**CITY OF CARMEL-BY-THE-SEA
PLANNING COMMISSION
REGULAR MEETING AGENDA**

August 13, 2014
Wednesday
Tour – 2:00 p.m.
Meeting – 4:00 p.m.

Planning Commission Report

EXISTING +
PROPOSED
SITE PLAN

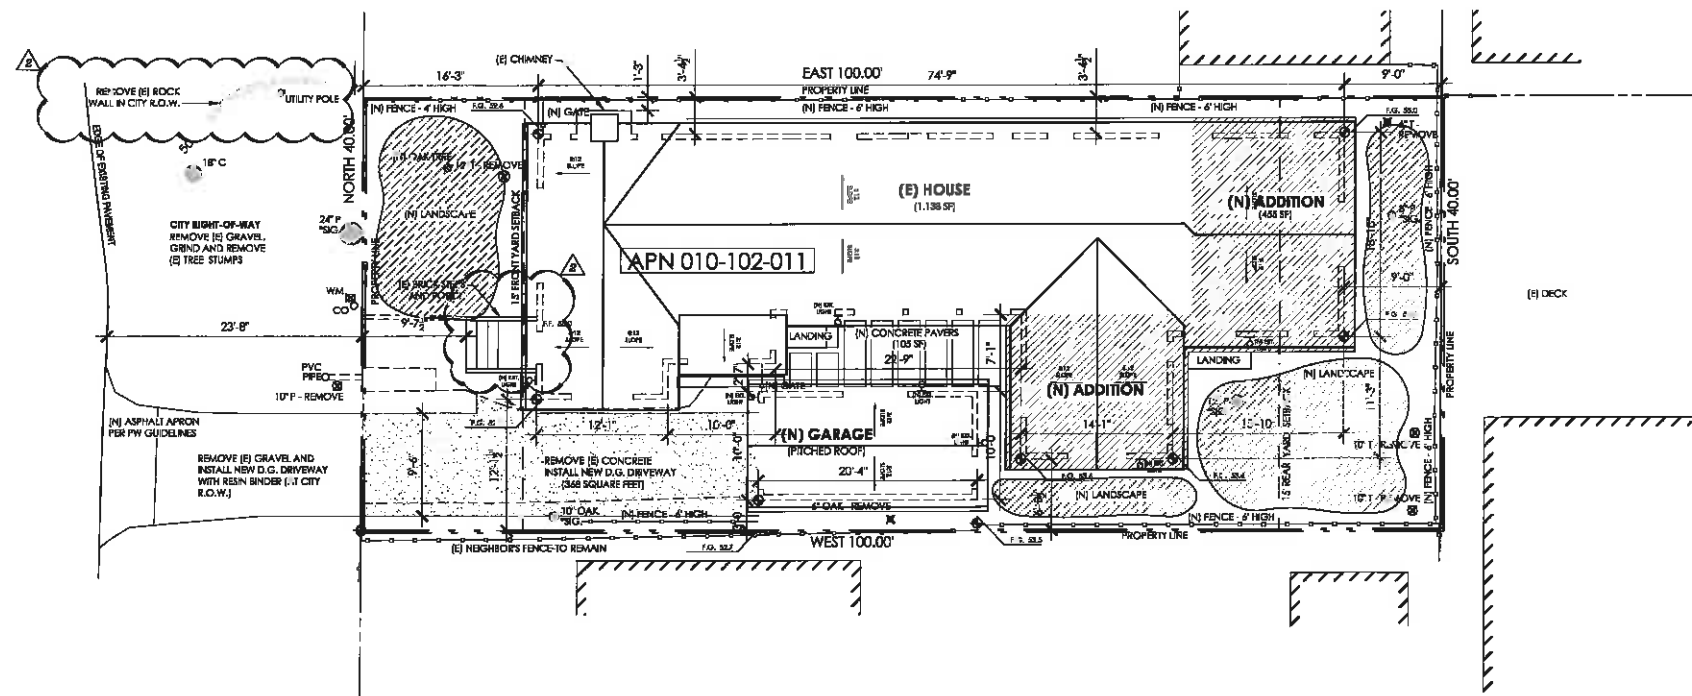
1. *The applicant shall remove the non-significant buckthorn due to high risk of fail at the soil line and shall remove ivy from the site and City ROW. These changes shall be noted*

2. *The applicant shall provide a note on the proposed site plan and building plans that identifies the following materials for the driveway. The driveway within the City ROW and the short return shall be decomposed granite with a resin binder. The driveway within the property boundaries shall be loose decomposed granite to maintain permeability.*

3. *As part of the submittal of the Final Design Review plans, the applicant shall revise plans showing that the new garage has been shifted out of the 3-foot minimum southern side-yard setback. The garage shall have a pitched roof to match the original character of the residence.*

4. *Prior to final building inspection, the applicant shall remove all existing gravel and the rock wall located in the City ROW as indicated on the project plans. The existing gravel and rock wall shall be noted as proposed for removal on the site and landscape plans submitted for final Planning Commission review.*

Analysis: The proposed site plan and landscape plan include a note stating “The non-significant Italian buckthorn shall be removed, due to high risk of fail at the soil line and all ivy shall be removed from the site and City ROW.”

Analysis: The proposed site plan calls out the driveway materials as recommended and the proposed site plan includes a note stating, “Within the City R.O.W. and the short return, the driveway shall be decomposed granite with a resin binder. The driveway within the property boundaries shall be loose decomposed granite to maintain permeability.” In addition, when the applicant submits the building plans, planning staff have another opportunity to review the plans to ensure the conditions have been transferred to the building plan set.

Analysis: The new garage was originally proposed to be setback approximately 1-ft from the south property line, deviating from the standard 3-foot setbacks and composite side yard setback requirements. Following the recommendation by the Planning Commission, the applicant has relocated the new garage out of the side yard setback, and it is now located 3 ft from the south property line.

Analysis: The proposed site plan and landscape plan identifies all existing gravel and the rock wall in the City ROW and includes a note that these encroachments will be removed. In addition, during building plan check, planning staff will visit the site to make sure that all gravel and the rock wall have been removed from the City ROW.

PROPOSED LANDSCAPE PLAN

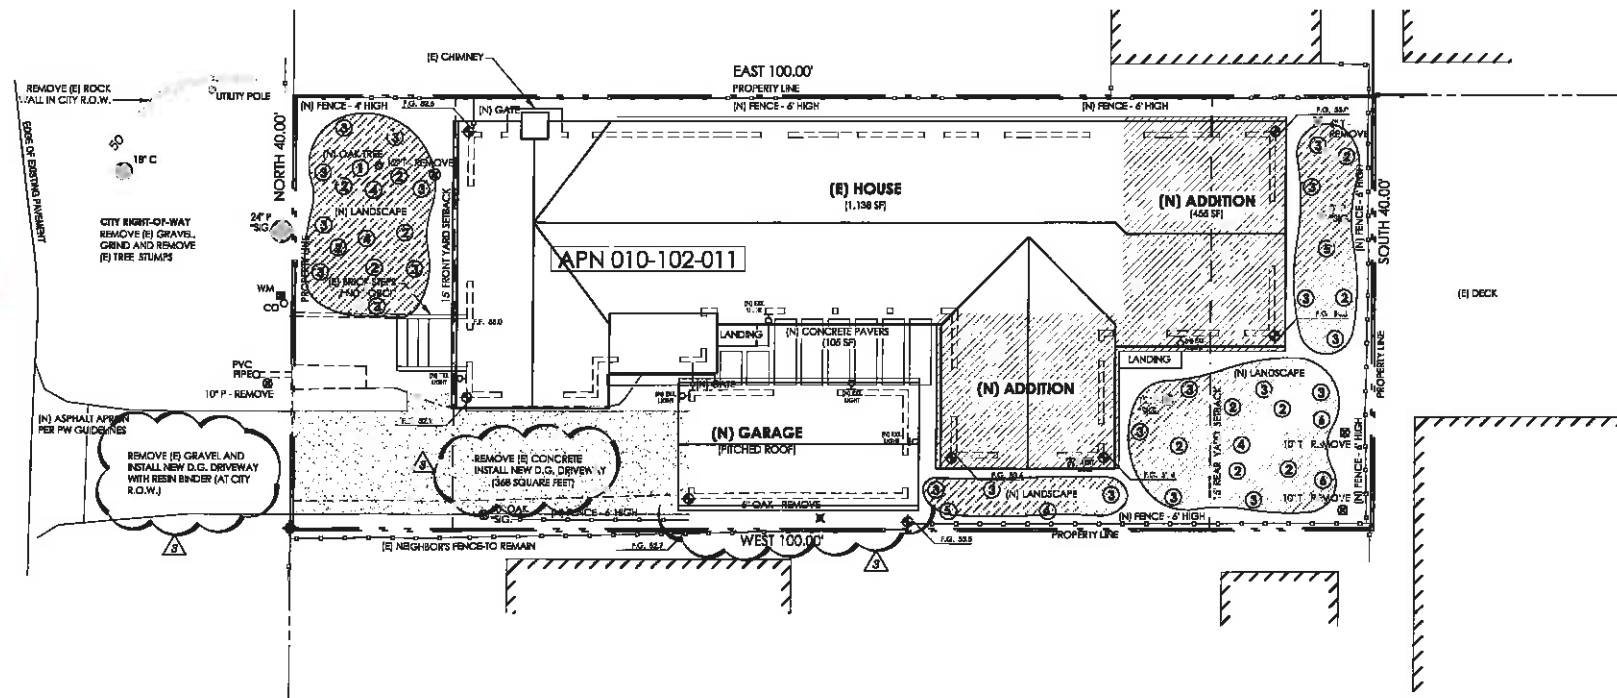
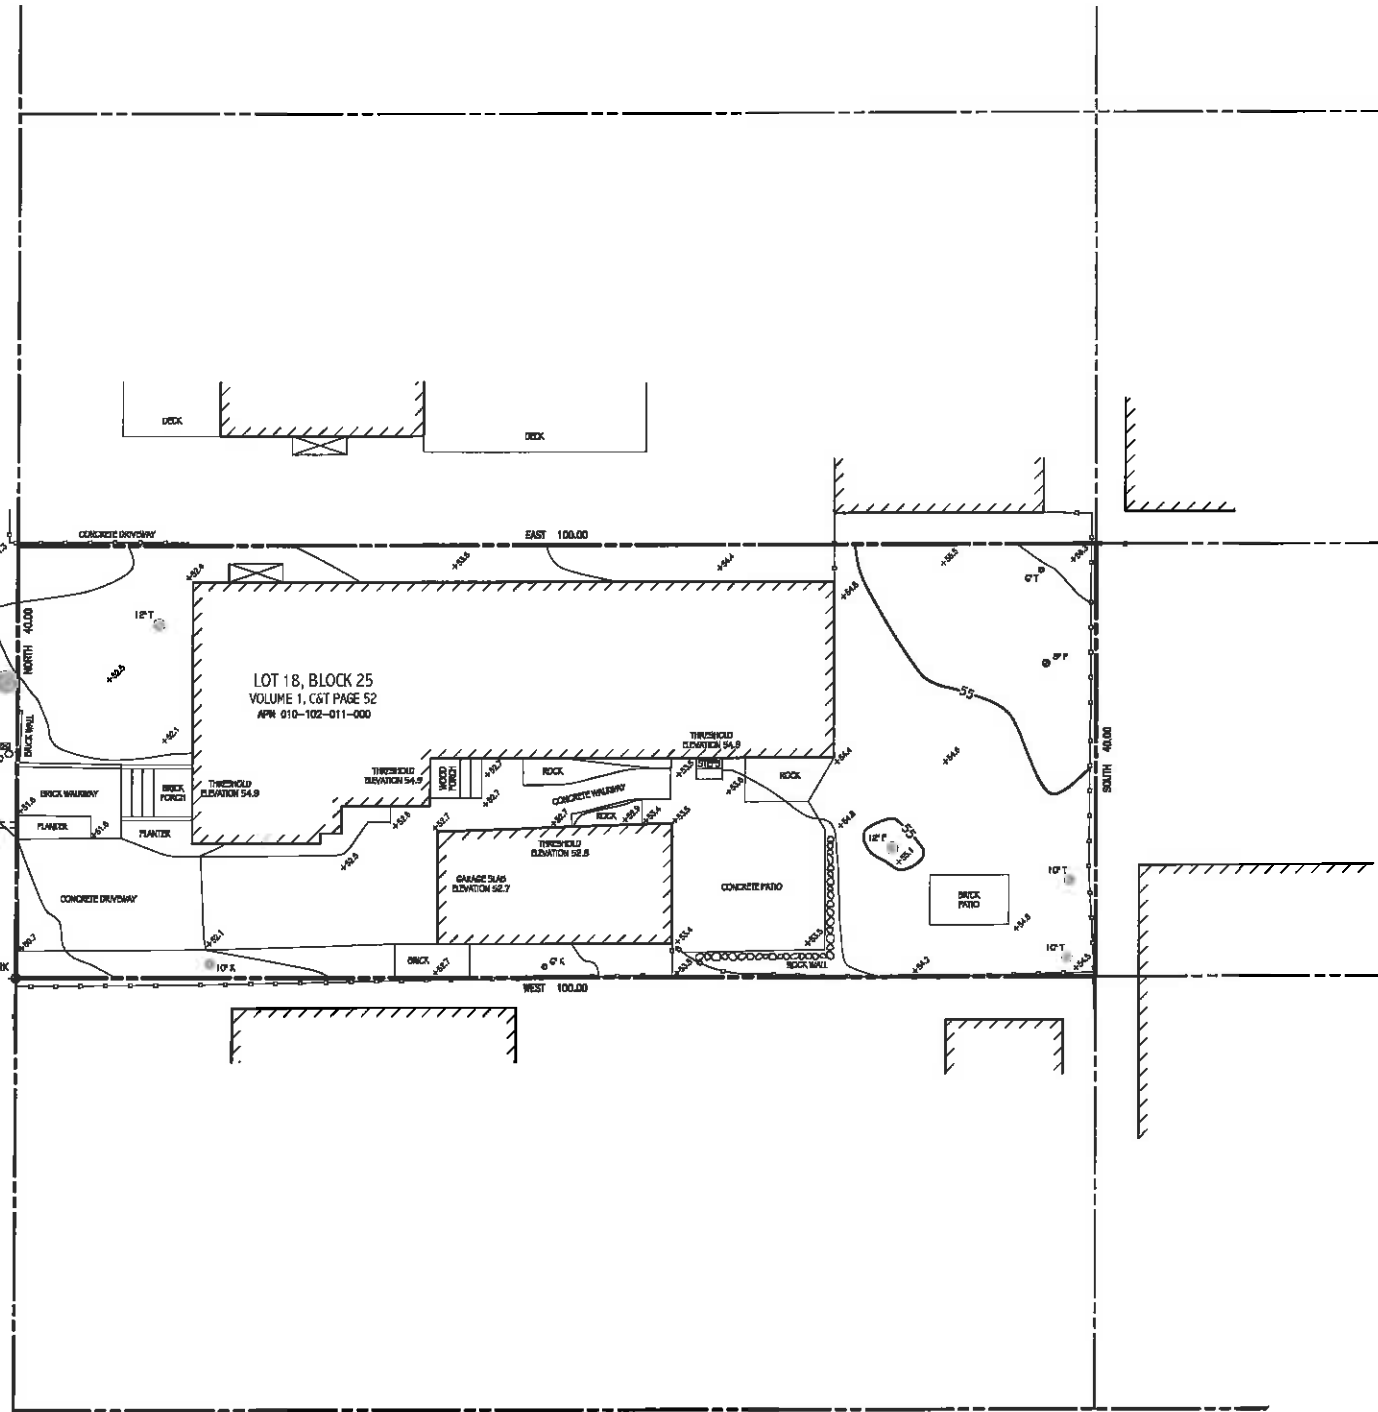
The applicant is proposing 13-W CFL exterior lights. This wattage generates a lighting intensity roughly equivalent to a 60-W incandescent bulb, which exceeds the City’s exterior lighting standards. A condition of approval has been drafted for the applicant to revise the lighting fixtures on the plan set to comply with City exterior lighting requirements.

25.	Prior to the approval of the Building Permit, the applicant shall revise the proposed elevations and landscape plan sheets to indicate exterior lighting fixtures that comply with Standard Condition #9.	✓
-----	---	---

DEMOLITION SITE PLAN

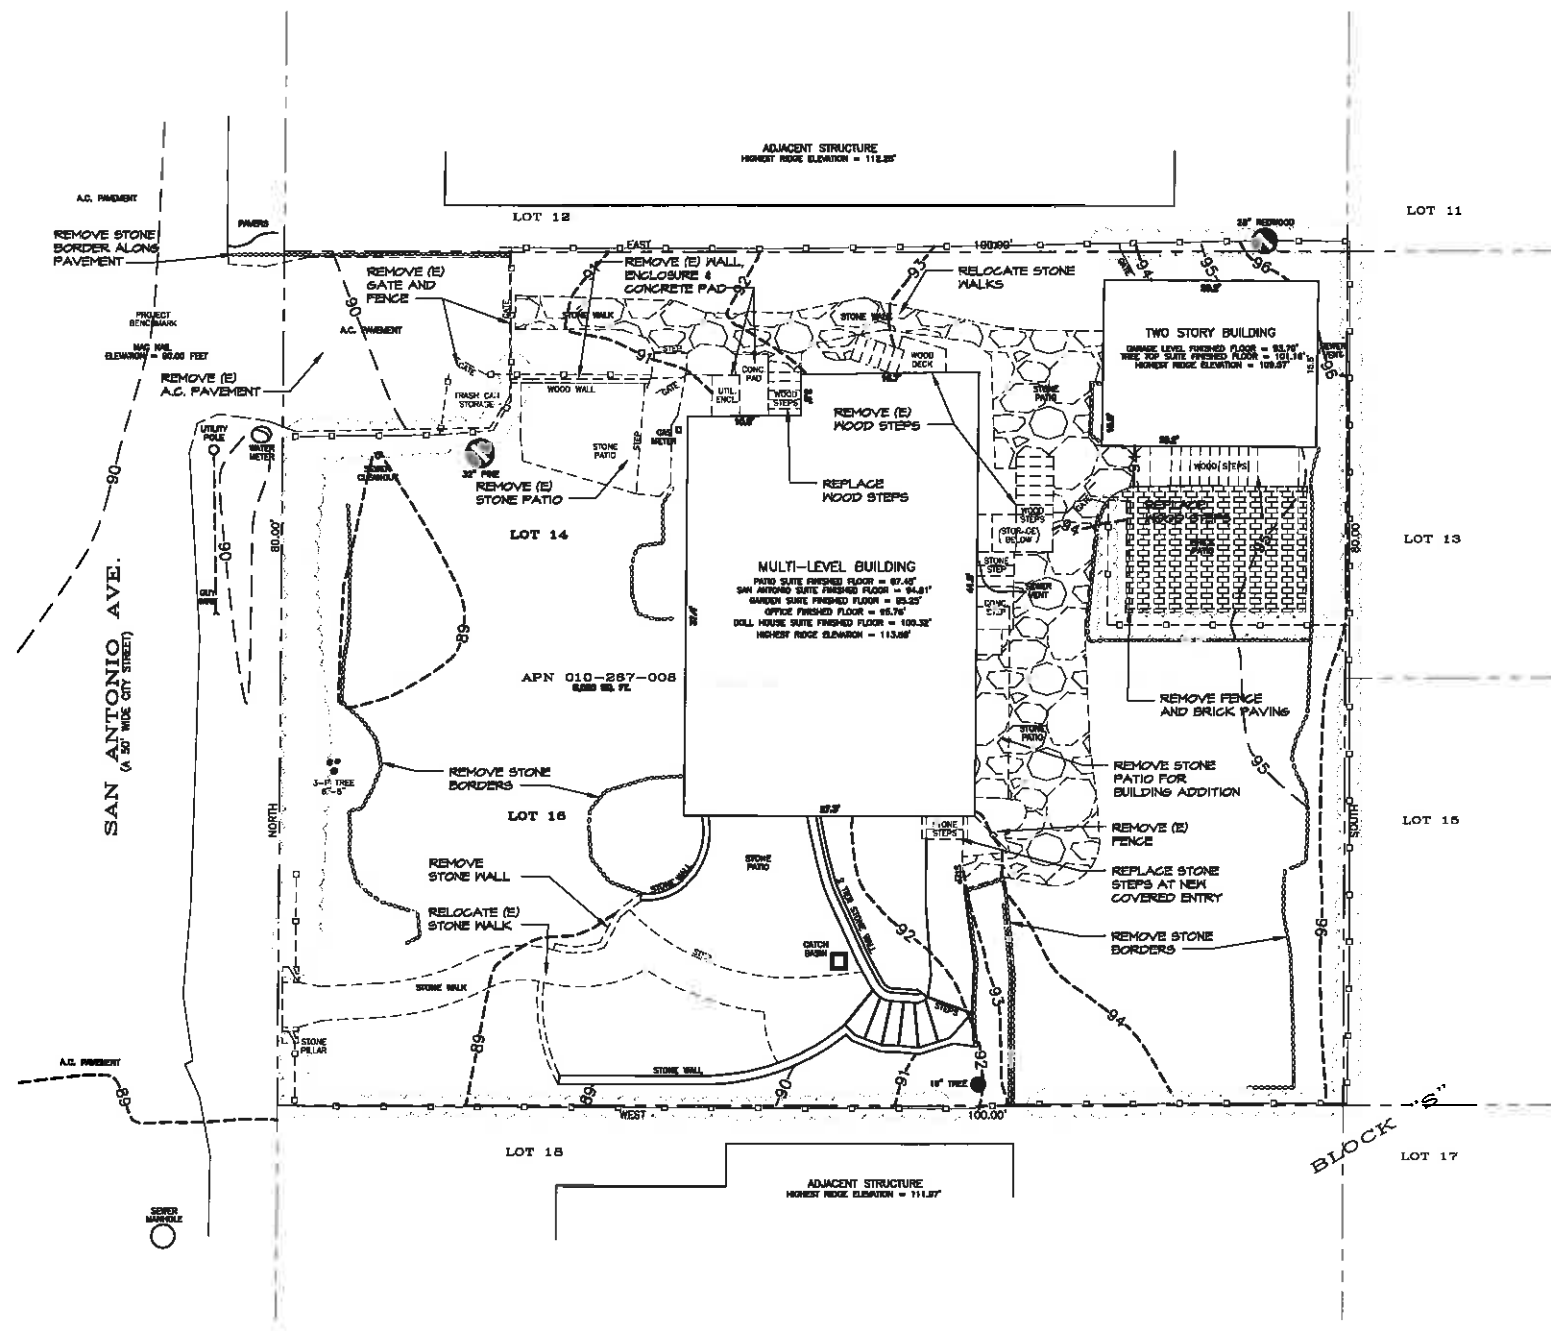
Public ROW: The City Right-of-Way at the front of the property is unpaved and is 8 feet wide between the front property line and the edge of San Antonio Avenue. The Demolition Plan on Sheet A-1.0 of the project plans notes that an existing rock wall in the City ROW near the northwest corner of the property will be removed. A condition has been drafted to ensure that this encroachment is removed.

COLUMN AND FENCE ELEVATION
SCALE: 1/2" = 1'-0"

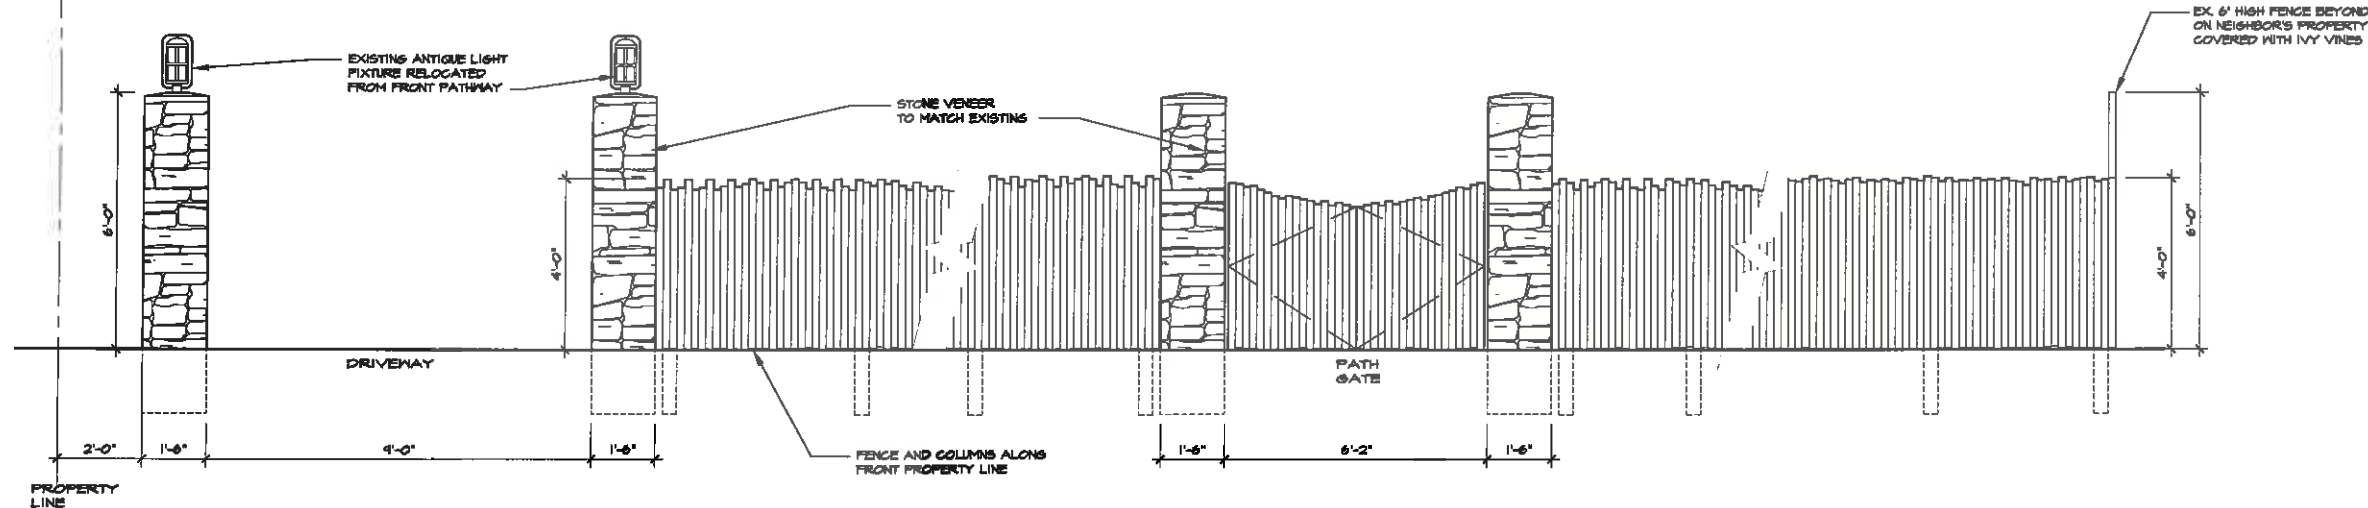
The project includes a proposal for a new 4-foot high solid wood fence at the front property line as depicted on Sheet A-1.2 of the plan set. The Commission should consider whether the proposed fence should have spacing between the pickets to be consistent with the above guideline.
